Airstream Service Bulletin

Bulletin Number: 174

Product Line: Airstream Atlas

Subject: Battery Fuse Replacement

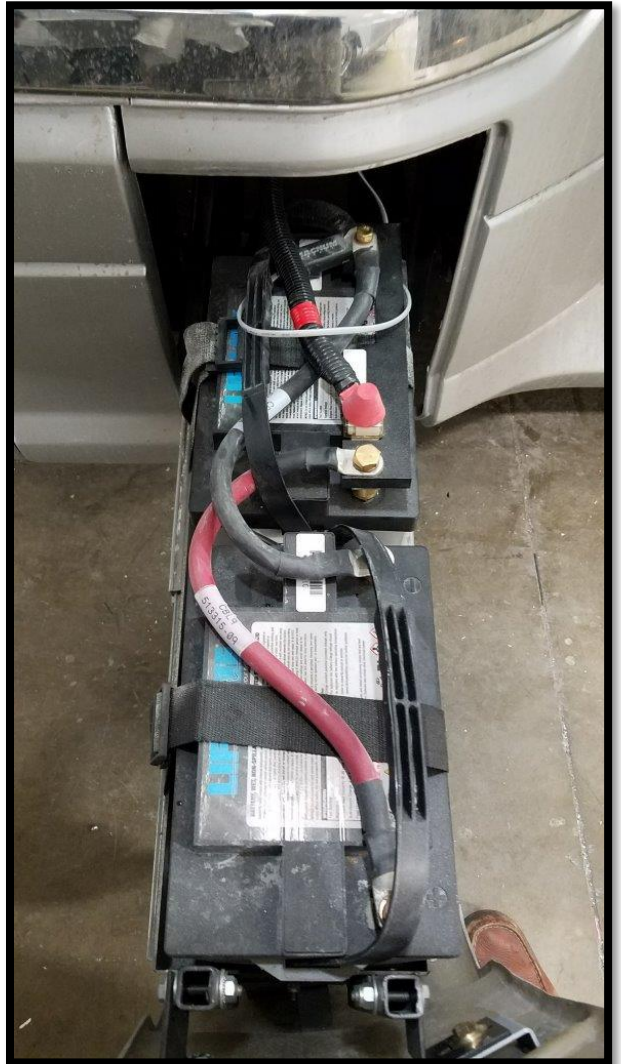
It has come to our attention that in certain scenarios the 150-amp fused circuit could potentially fail. This fuse controls 12 volt operation within the coach. Therefore, we are upgrading the fuse to the 200-amp fuse.

Step 4: Replace the 150 amp fuse with the 200 amp fuse (**Part # 512660-200**) and re-attach the battery cable and nut. The torque rating for this nut is 75 inch lbs.

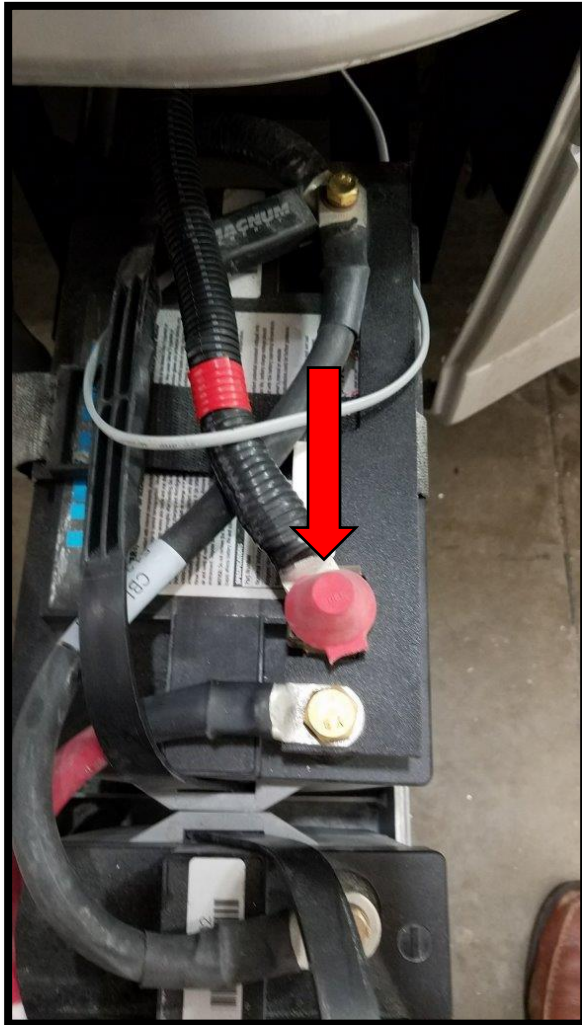
Step 1: Start by accessing the batteries. The compartment is located on the curbside behind the passenger side door. You will need to remove the pin under the compartment and slide the compartment out.
